## 9.5 Other Auxiliary Systems

The information in this section of the reference ABWR DCD, including all subsections, tables, and figures, is incorporated by reference with the following departures and supplements.

Figure 9.5-2 Outline - Telephonic Communication System for Single Unit of STP 3 or 4

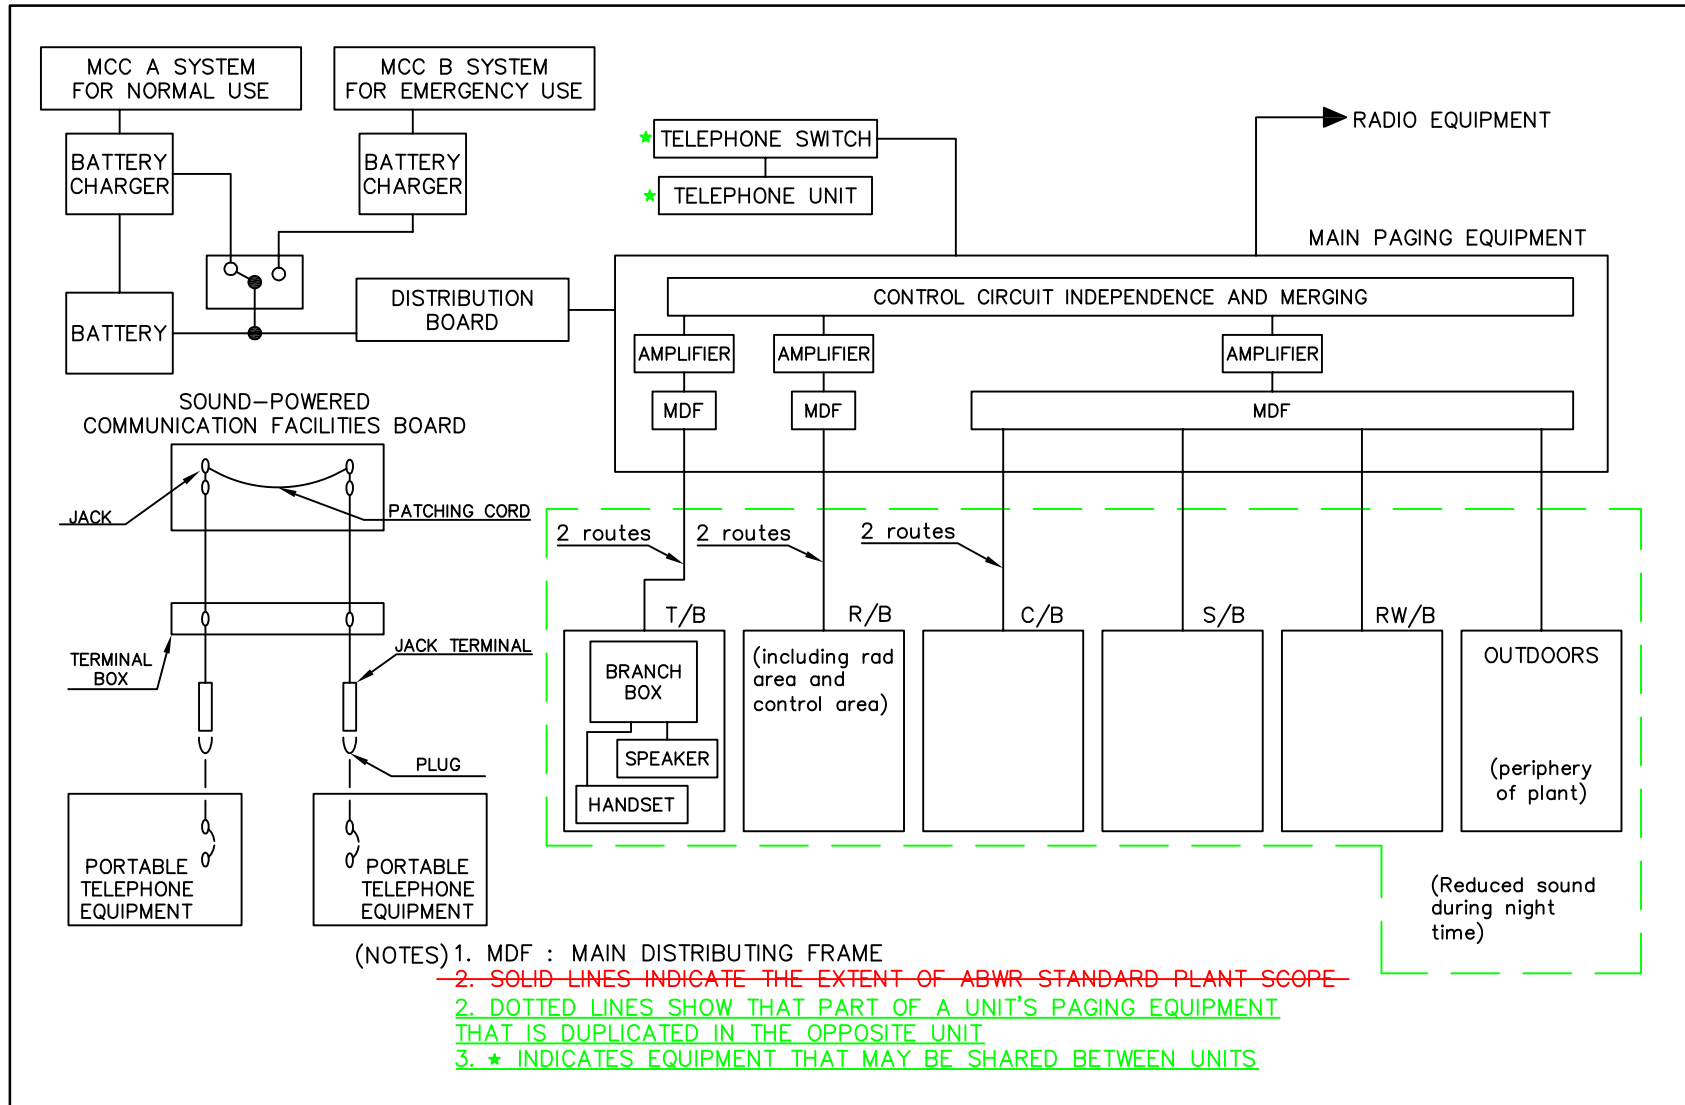
STP DEP 1.1-2 (Figures 9.5-2, 9.5-4 and 9.5-5)

At STP 3 & 4, a common communication system is used to provide plant-wide communications between the dual units. The communication system is not safety-related. A common communication system providing plant wide communications is a safety enhancement since it allows for ease of communication between units. The representative outline of the common communication system is shown in Figure 9.5-2 for STP 3 & 4.

**Figure 9.5-3 Lower Drywell Flooder System Arrangement/Configuration**

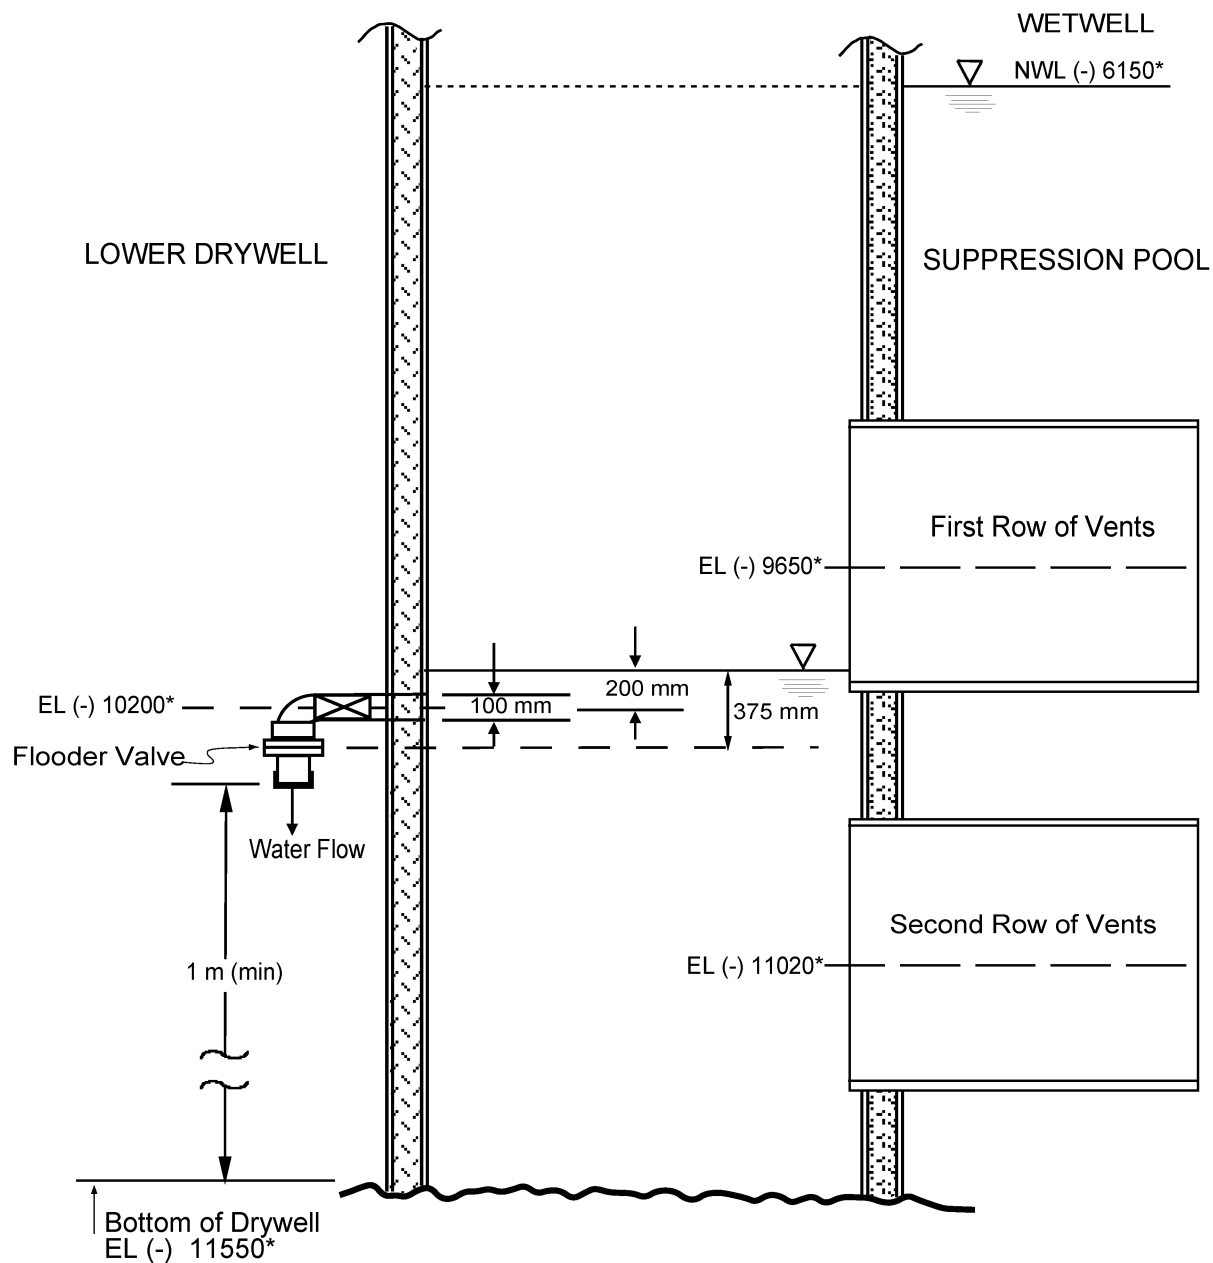
STD DEP 9.5-2 (Figure 9.5-3, replaced entire figure)

The LDF, shown schematically in Figure 9.5-3, provides a flow path for suppression pool water into the lower drywell area during severe accident scenario that leads to core meltdown, vessel failure, and deposition of molten corium on the lower drywell floor. Molten corium is a molten mixture of fuel, reactor internals, the vessel bottom head and control rod drive components. The flow path is opened when the lower drywell airspace temperature reaches 260°C ± 10°C.

The LDF consists of ten pipes that run from the vertical pedestal vents into the lower drywell. Each pipe ~~contains~~ has an isolation valve and a fusible plug valve connected to the end of the pipe that extends into the lower drywell ~~by a flange.~~ The fusible plug valves open when the drywell air space ~~(and subsequently the fusible plug)~~ temperature reaches 260°C ± 10°C. When the fusible plug valves open, a minimum of 10.5 L/s of suppression pool water will be supplied through each flooder pipe (105 L/s total) to the lower drywell to quench the corium, flood the lower drywell and remove corium decay heat, which is estimated at 1% of rated thermal power. The flow rate is based on a minimum hydrostatic head of 200 mm above the flooder pipe inlet centerline and takes the frictional losses through the flooder pipe and fusible plug valve into account.

Figure 9.5-4 Fire Protection Water Supply System

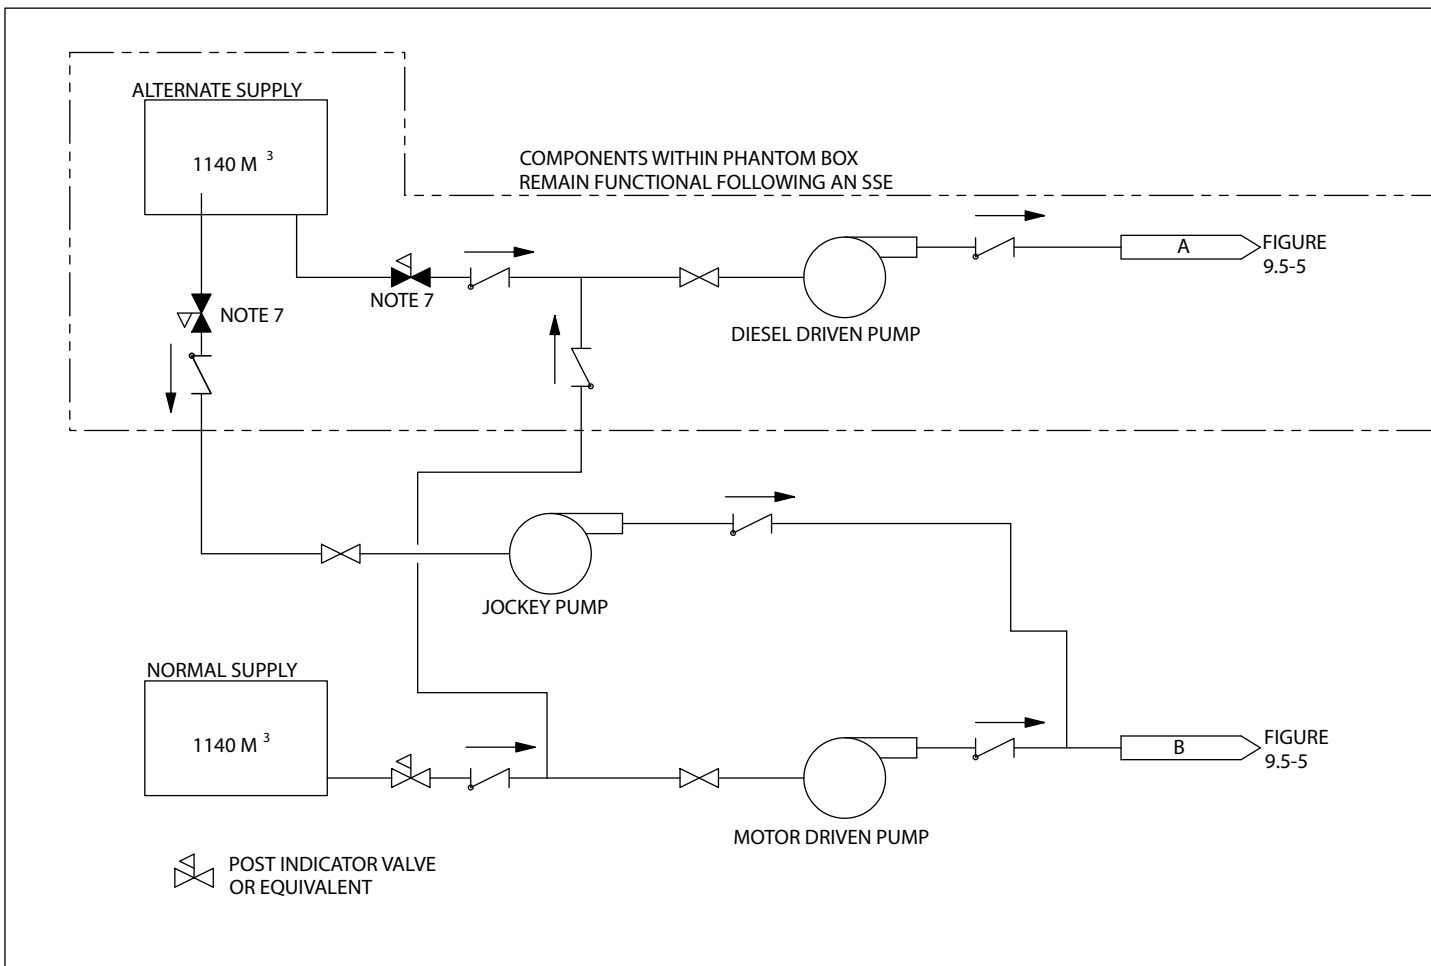
STP 3 & 4 is a dual-unit station. The water supply for fire protection will be shared by STP 3 & 4. A single fire protection pump house and two storage tanks are located within the protected area boundary that provides water for fire suppression to both units via piping in the yard. This common system has the same capability as the system for the single unit design. The fire protection water supply complies with Regulatory Guide 1.189, Rev. 1, which states that a common water supply may be utilized for multi-unit nuclear power plant sites with a common yard fire main loop. The common fire water supply and yard main piping system for STP Units 3 & 4 are depicted in Figures 9.5-4 and 9.5-5. The common yard fire main loop surrounding STP Units 3 & 4 is cross-connected between units in accordance with Regulatory Guide 1.189, Rev. 1.

Figure 9.5-5 Fire Protection Yard Main Piping

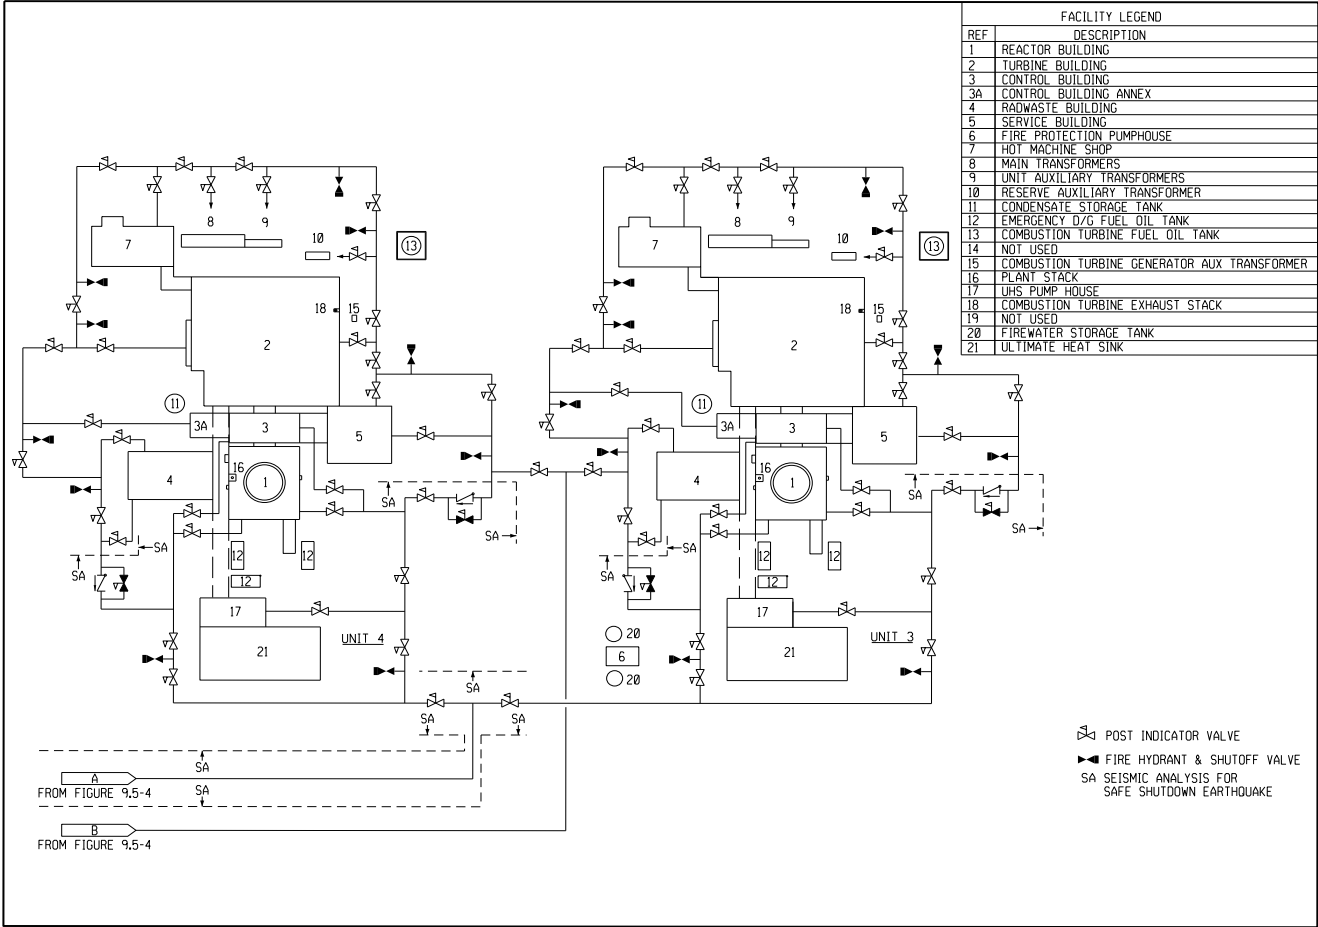
<b>Area</b>	<b>Figures</b>
<i>Service Building</i>	9A.4-22 thru 9A.4-27
<i>Radwaste Building</i>	9A.4-28 thru 9A.4-32
<i>Plant Yard</i>	9.5-5
